### **Request for Information #1**

## Sommet Blanc-Building C

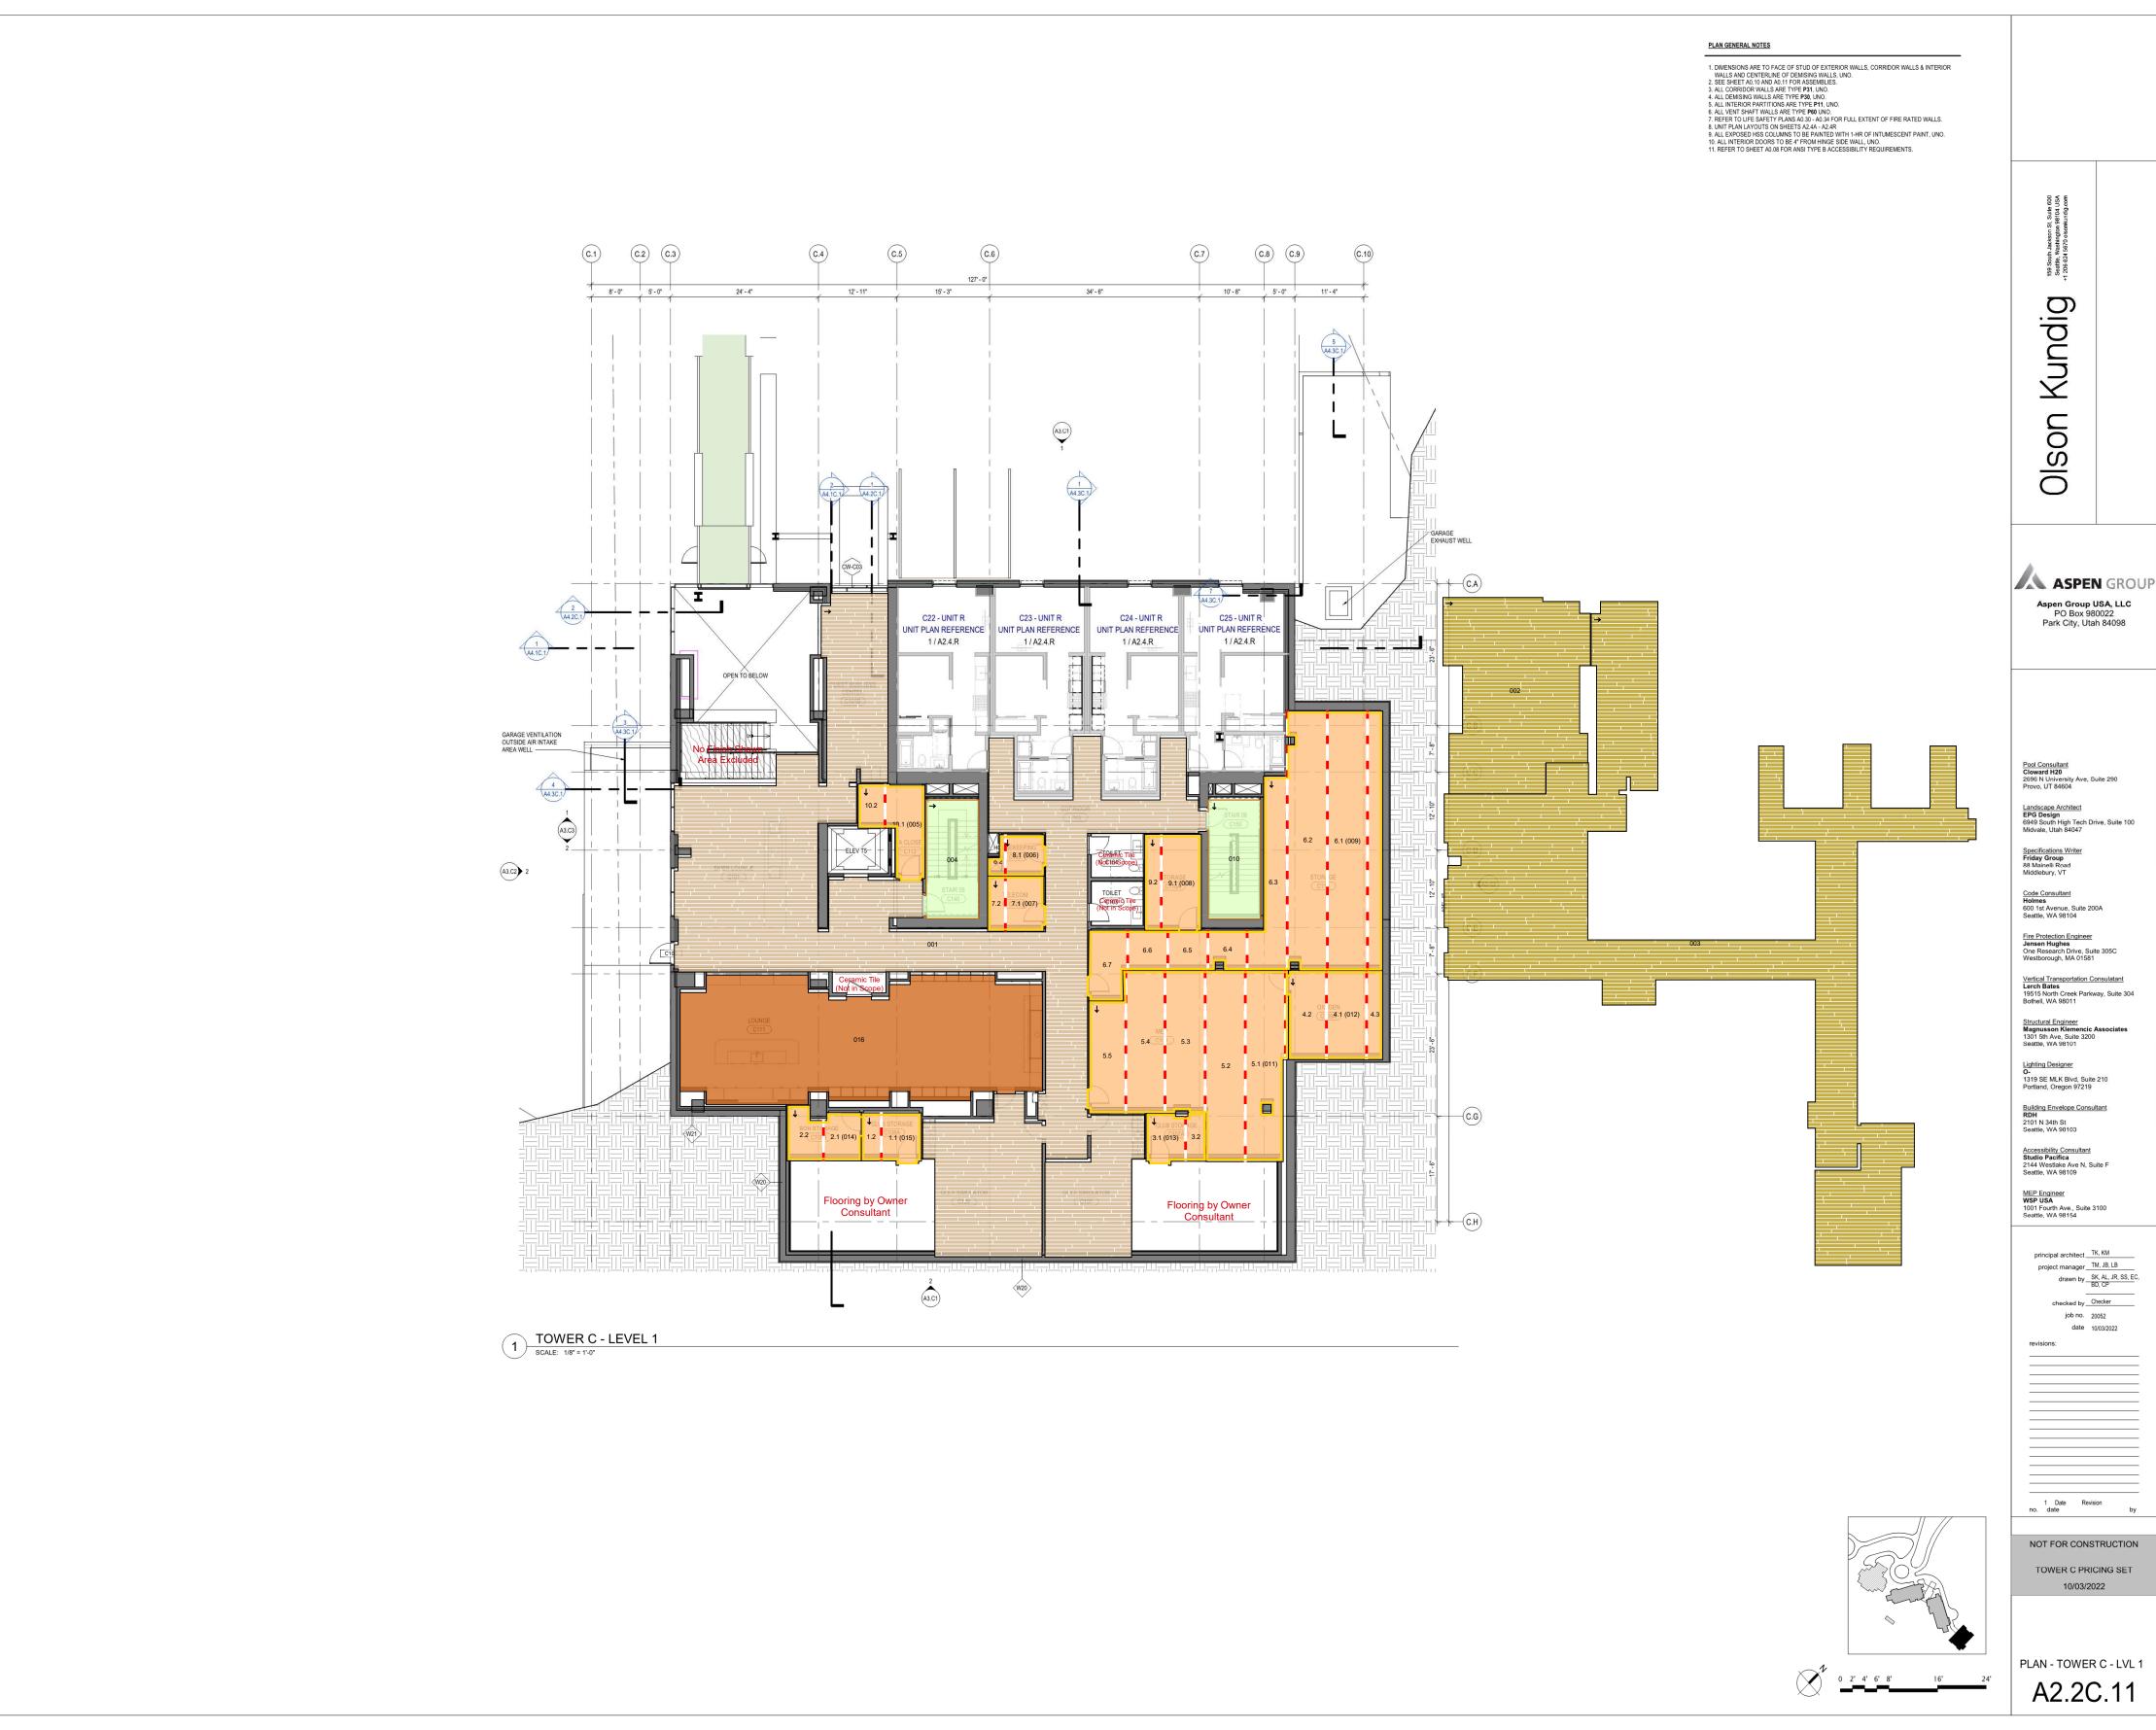
- All Electrical & Control Rooms on Level P1 The finish plan on A2.5C.01 do not show any finishes for these areas. Please clarify floor/base finishes. Assumed that these areas are to receive a Sealed Concrete (Not in Scope) w/Rubber Base finish for our takeoff.

- All Storage & Trash Rooms on Level P1 The finish plan on A2.5C.01 do not show any finishes for these areas. Please clarify floor/base finishes. Assumed that these areas are to receive a Sealed Concrete (Not in Scope) w/no base for our takeoff.

- All Egress Stairs 05 & 06 The finish plan on A2.5C.01 thru A2.5C.12 do not show any finishes for these areas. Please clarify floor/base finishes. Assumed that these areas are to receive a Sealed Concrete (Not in Scope) w/Rubber Base finish for our takeoff.

- 5. Elevator Cab The finish plan on A2.5C.01 thru A2.5C.12 do not show any finishes for this area. Please clarify. Assumed that this area is to receive WD-07 for our takeoff.

- 6. Stairs that go from Entry Lobby C001 to Skier Lounge C101 Finish plan A2.5C.01 & A2.5C.11 do not show a floor finish. Please clarify floor finish for these stairs. No floor finish figured for these stairs, excluded from our takeoff until clarified.

1 TOWER C - LEVEL 8 SCALE: 1/8" = 1'-0"

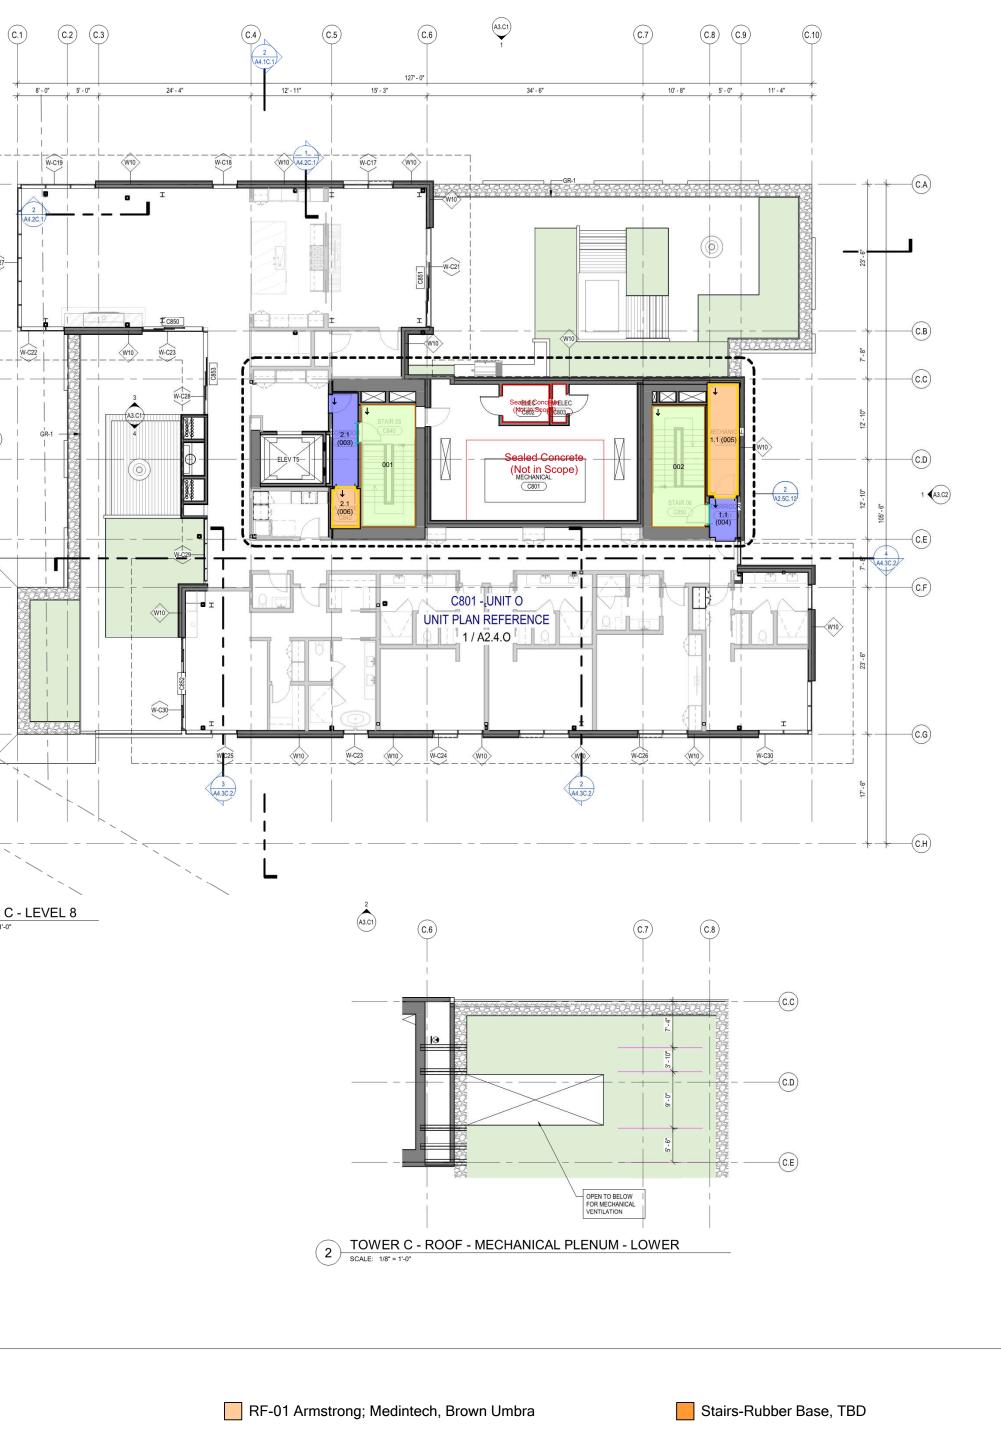
- Corridors C241, C251, C341, C351, C441, C451, C541, C551, C641, C651, C741, C751, C841 & C851 – Finish plan A2.5C.12 have the floor material listed as TBD. Please clarify floor/base finish in these areas. Assumed that a 12' Broadloom Carpet w/Wood Base (Not in Scope) is to be used for these areas for our takeoff.

- 8. All Electrical Rooms on Level 8 The finish plan on A2.5C.12 do not show any finishes for these areas. Please clarify floor/base finishes. Assumed that these areas are to receive a Sealed Concrete (Not in Scope) w/Rubber Base finish for our takeoff.
- 9. Mechanical C801 The finish plan on A2.5C.12 do not show any finishes for this area. Please clarify floor/base finishes. Assumed that this area is to receive a Sealed Concrete (Not in Scope) w/no base for our takeoff.
